Updated Exhibit List – Noll Pointe PRD and Preliminary Plat  
September 18, 2026

**To:** Hearing Examiner  
**From:** Edie Berghoff, Senior Planner  
**Subject:** Noll Pointe Planned Residential Development | P-09-10-25-01  
**Date:** September 18, 2026

**To:** Hearing Examiner  
**From:** Edie Berghoff, Senior Planner  
**Subject:** Application of Alternative Tree Retention/Replanting Option, Noll Pointe PRD (P-09-10-25-01)  
**Date:** September 3, 2026

To: Edie Berghoff, City of Poulsbo Associate Planner  
 From: Kevin M. McFarland, City of Poulsbo Contracted Arborist  
 Date: 11/18/2025  
 Re: Noll Pointe PRD Review, Project #P-09-10-25-01

## LANDSCAPE PLAN

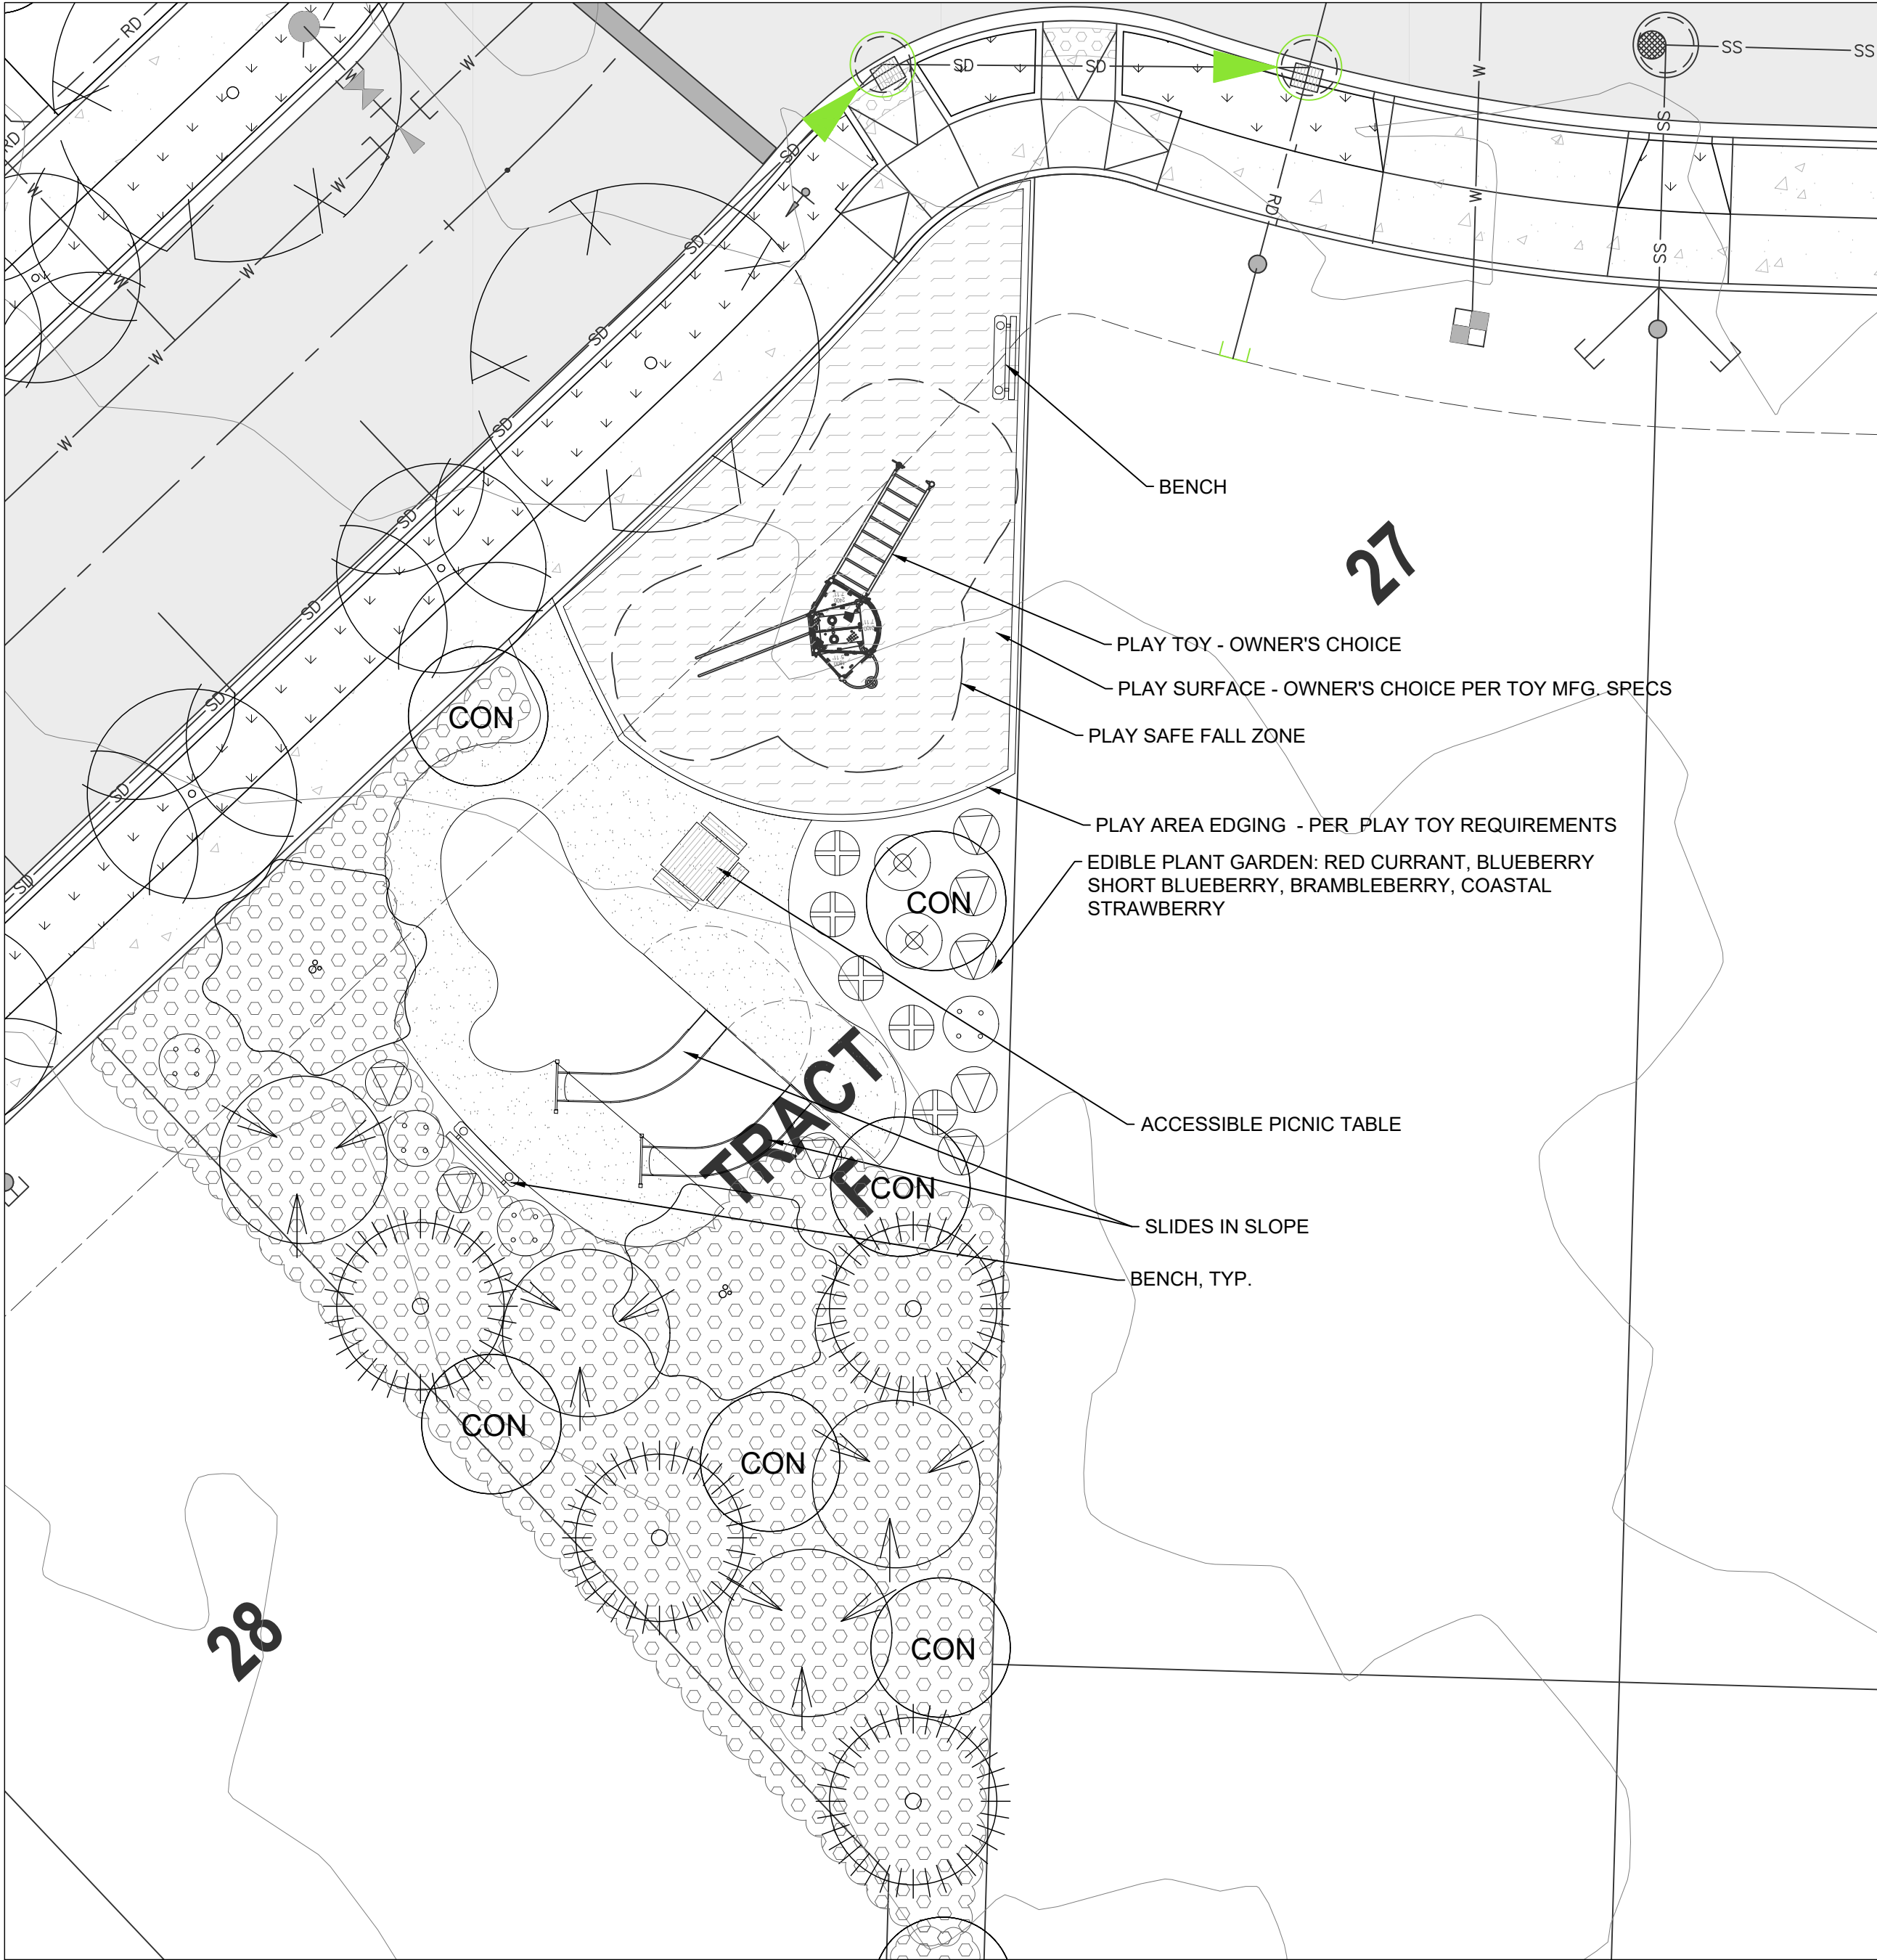
All tree retention tracts here are currently forested. These areas are stipulated in the TPP as "Tree Retention", not replanting areas.

Show table of Tract Sizes. All tree retention tracts will need to show total size of conserved forest and total number of preserved significant trees per tract.

This should be similar to the Tract Summary Table on Sheet C1.10 on civil plans, but include tree retention numbers per tract.

It appears there are overhead utilities here, and a utility easement that stretches 20-feet into this Tract. Verify location of overhead utilities and suitability of tree installation.

Conifer tree shown planted in front of sign.

Show Tree Protection Fencing and Signage on Landscape Plan and provide for inclusion on Civil Plan.

Potential planting opportunity in this area. Planting must be in separate tract outside of the Stormwater Tract. See comment 1.5.

DECIDUOUS TREE PLANTING & STAKING DETAIL

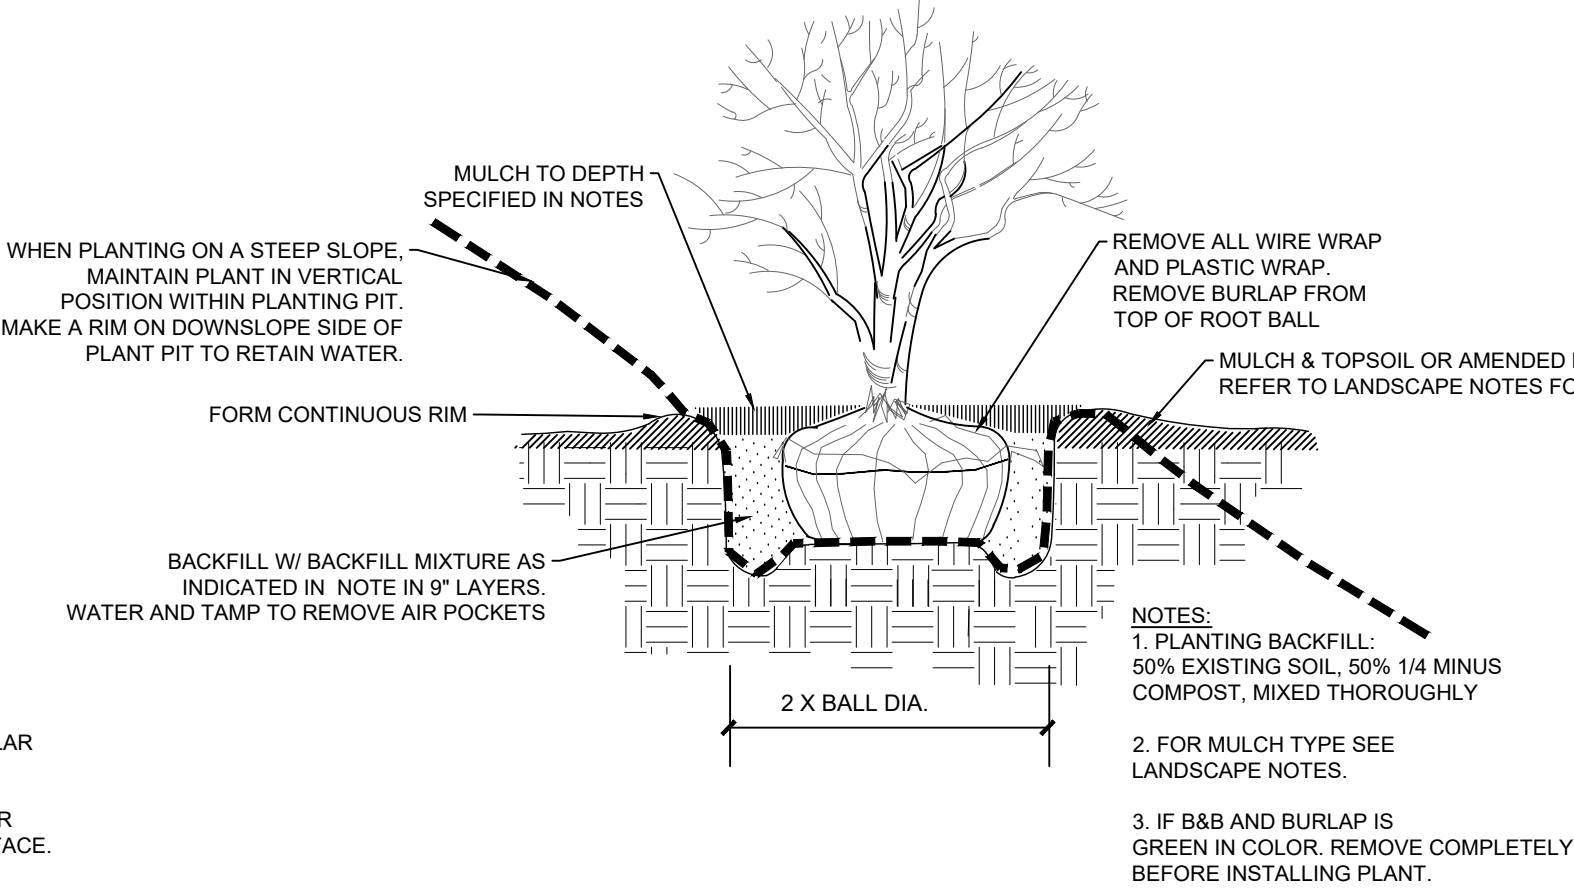
Need Tree Protection Fencing and Signage details, Need details for permanent tree protection area fencing.
